MPI figures and text on current flow: Comments 6, 48, 49, and 67

CME Consulting/ADI, APL Group, Cisco, Marvell, OnSemi, SenTekSe, Sony
IEEE 802.3da telephonic Interim
September 4, 2024

Comments 6, 48, 49, and 67

Figure 169-2—Current at the MPSE MPI

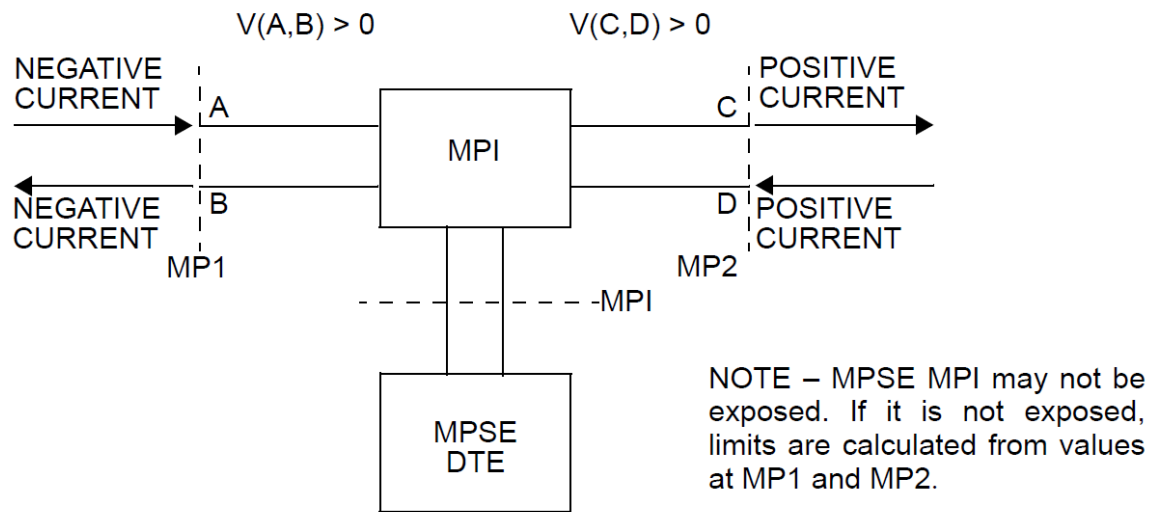
Figures are identical except for:
 Polarity of current (positive vs. negative relative to the voltage), labels of MPSE and MPD, and errors (“MPSD”, and text box on $V(A,B) > 0$ and $V(C,D) > 0$ on Fig 169-5)

Consolidate figures 169-2 and 169-5 into a single figure, and bring repetitive text in the MPSE and MPD MPI sections regarding how to treat voltage and current specifications into a general section describing conventions in this clause. Note - Comment 18 would create a new clause “169.1.3 Conventions in this clause”

Move figure 169-2 from 169.4.3 to 169.1.3.4, (following the inserted text above) deleting “MPSE” in both the DTE box and the NOTE.

Figure 169-5—Current at an MPD MPI

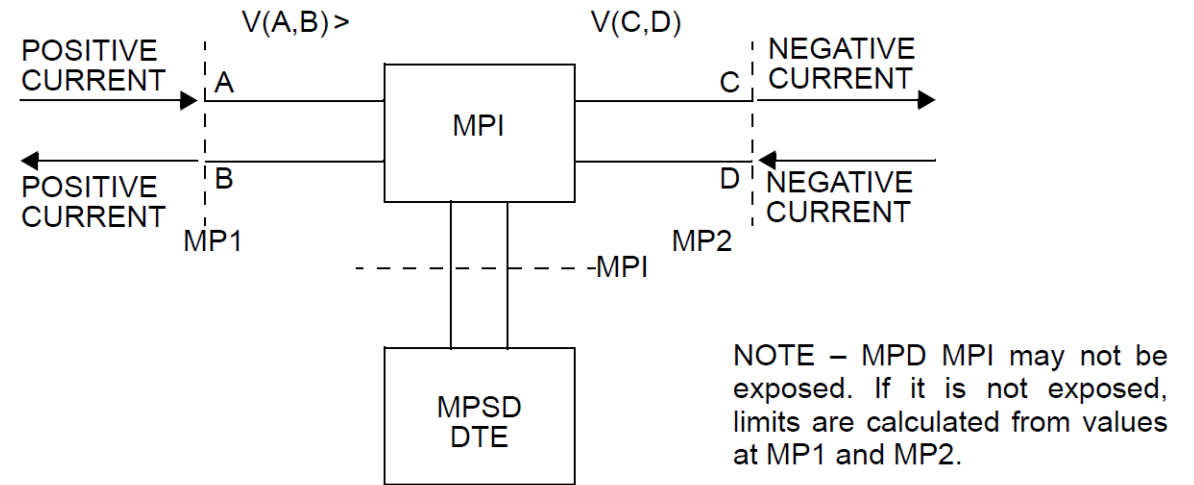
Cl 169 SC 169.5.2 P111 L20 # 6 [REDACTED]
Jones, Chad Cisco Systems, Inc.
Comment Type E Comment Status D EZ
Figure 169-5, V(A,B) has a greater sign after it. Not sure if it is a typo or if it suppose to indicate $V(A,B) > V(C,D)$. In either case, something needs done to the drawing. Either we delete the > symbol, or we move V(C,D) closer to make it obvious what we are trying to say. I'd lean towards it being a typo as we don't discuss that V(A,B) has to be greater than V(C,D) [even though logically it should be].
SuggestedRemedy
delete the ">" from the drawing.
Proposed Response Response Status W
PROPOSED ACCEPT.

Delete Figure 169-5 from 169.5.2. (P111)

Change “See Figure 169-5” in the 2nd paragraph of 169.5.2 (P110 L49) to “See Figure 169-2”.
